AURIX™ TC35x errata sheet

Marking/Step: (E)ES-AB, AB

About this document

Figure 1 Message buffer transfer from Message RAM to OBF

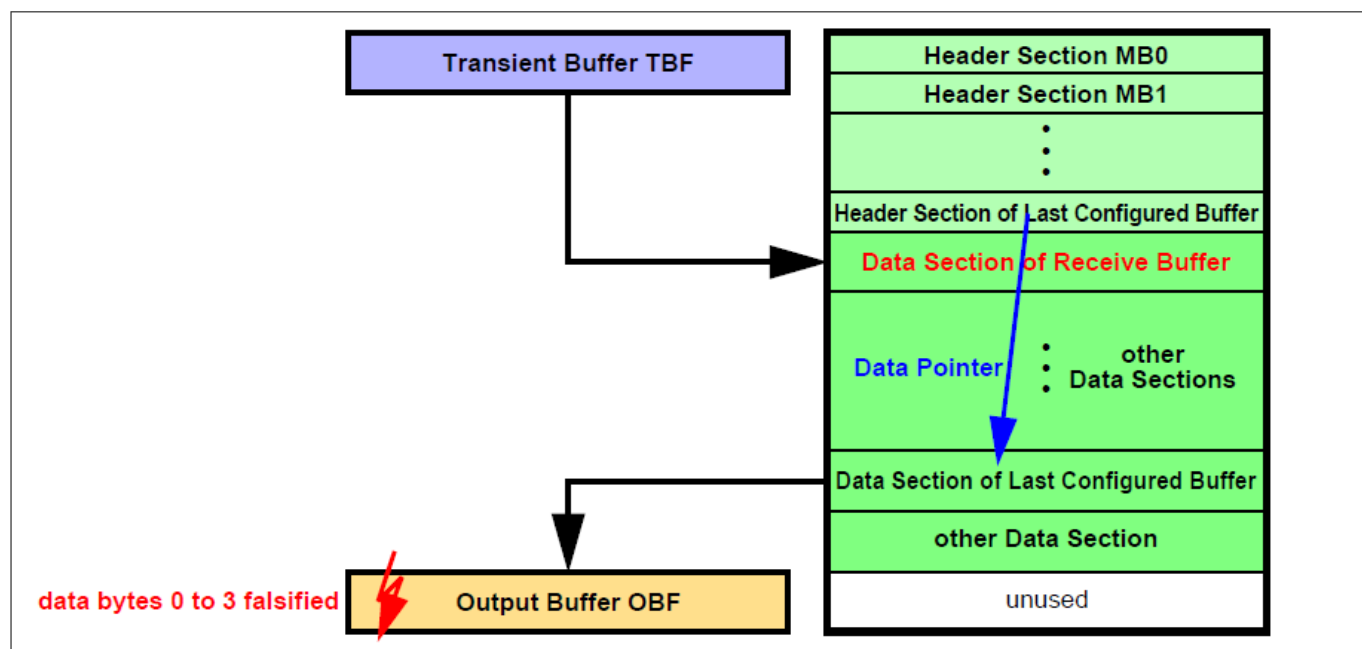
When the message buffer has its payload configured to maximum length (PLC = 127), the OBF word on address 00h (payload data bytes 0 to 3) is overwritten with unexpected data at the end of the transfer.

a) When a message is transferred from the Last Configured Buffer in the Message RAM to the OBF and PLC = 127 it may happen, that at the end of the transfer the OBF word on address 00h (payload data bytes 0 to 3) is overwritten with unexpected data (see [Figure 1](#))

Ensure that the Data Section directly following the Header Partition is assigned to a transmit buffer.

Figure 2 Message buffer transfer from IBF to Message RAM

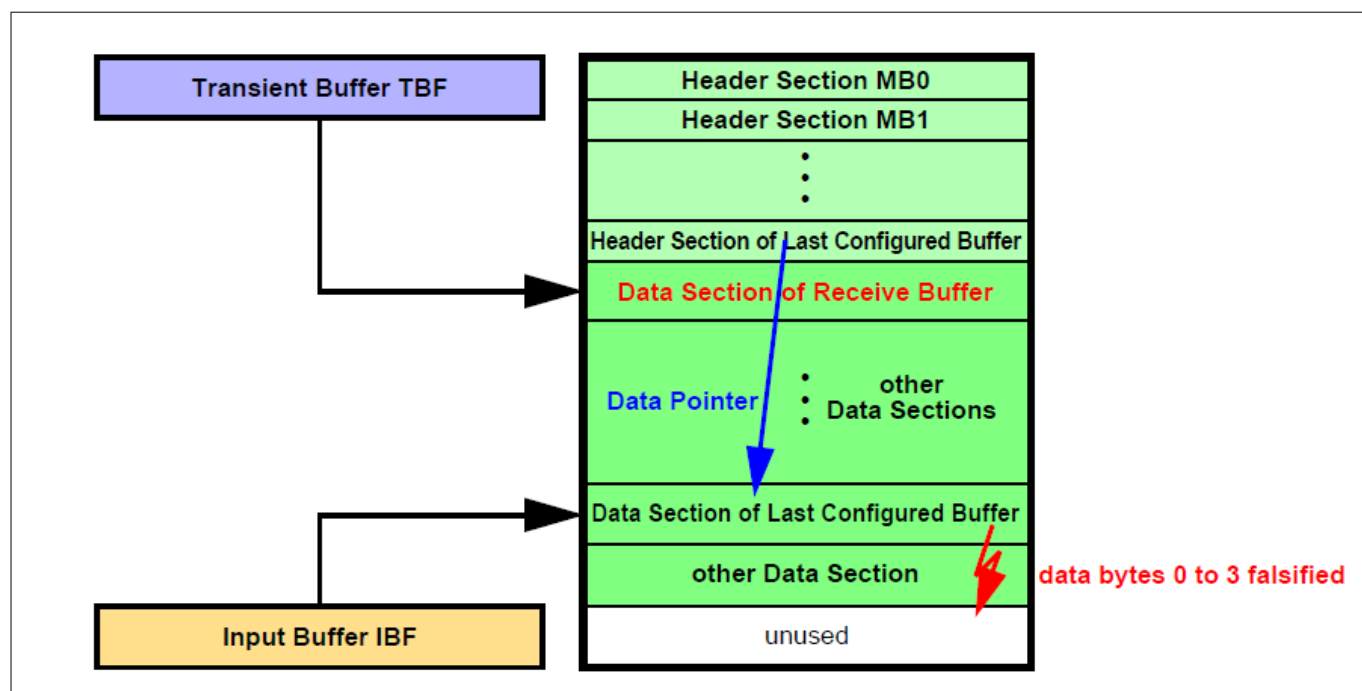
After the Data Section of the selected message buffer in the Message RAM has been written, one additional write access overwrites the following word in the Message RAM which might be the first word of the next Data Section.

b) When a message is transferred from IBF to the Last Configured Buffer in the Message RAM, it may happen, that at the end of the transfer of the Data Section one additional write access overwrites the following word, which may be the first word of another message's Data Section in the Message RAM (see [Figure 2](#))

Figure 3 Message RAM configurations

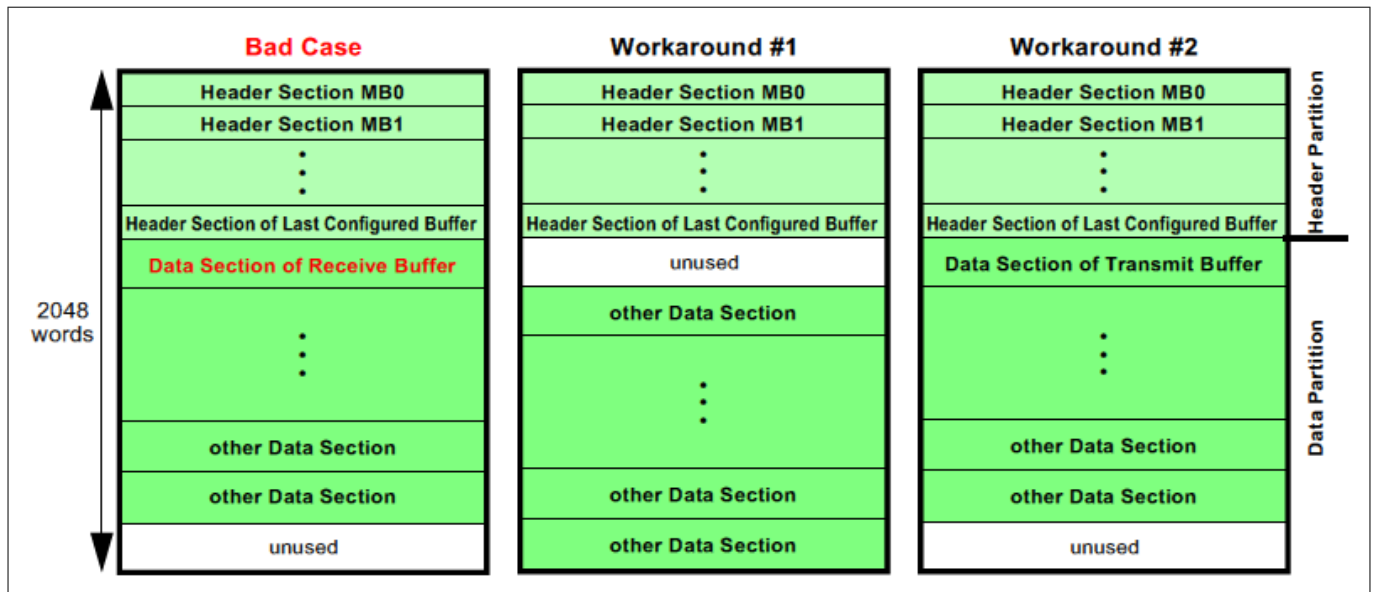
The erratum is limited to the case when (see [Figure 3](#) “Bad Case”):

Figure 5 CAN Frame with DLC > 4

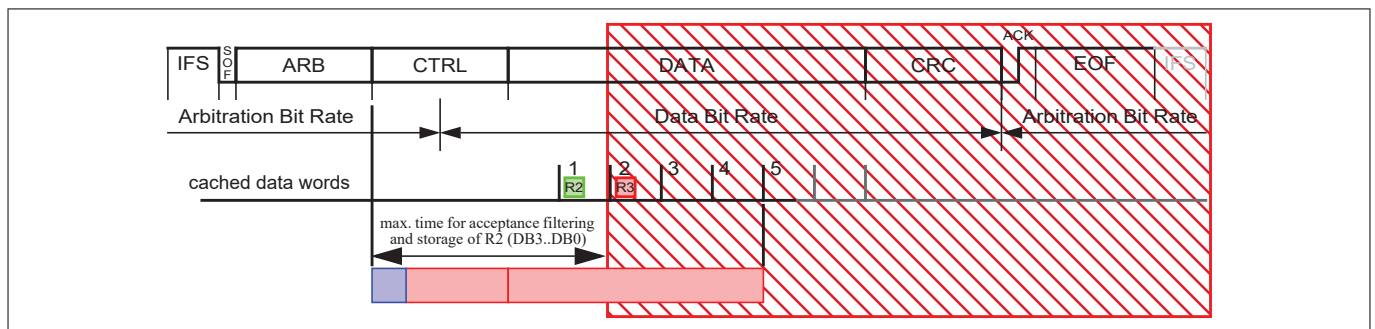
The issue may occur in FD Frame Format as well as in Classic Frame Format.

The figure that follows shows how the available time for acceptance filtering and storage is reduced.

Due to condition 3) the issue only occurs sporadically. Use an end-to-end (E2E) protection (for example, checksum or CRC covering the data field) and add it to all messages in the CAN system, to detect data corruption in received frames.

Figure 6 Positive overload on P-pad of a LVDS RX pin pair (both used as inputs)

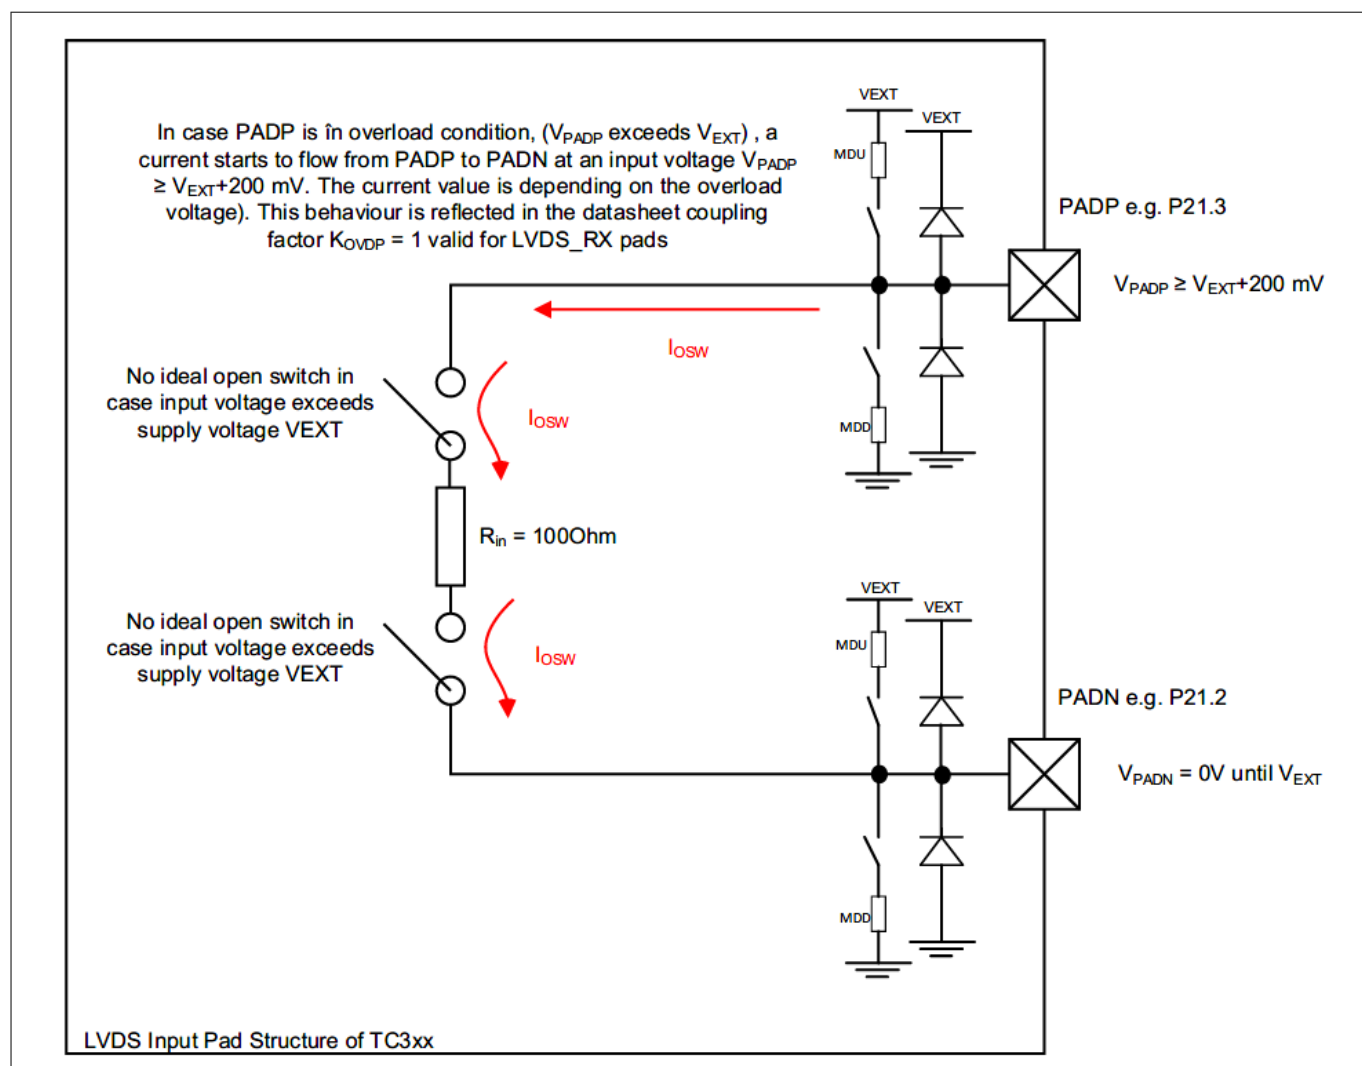
The overload current I_{OSW} through the non-ideal open switch significantly increases when $V_{PADP} \geq V_{EXT} + 200$ mV.

Note: In general, the effect will also occur if the N-pad is used as output, or for a negative overload condition on either the P-pad or the N-pad.
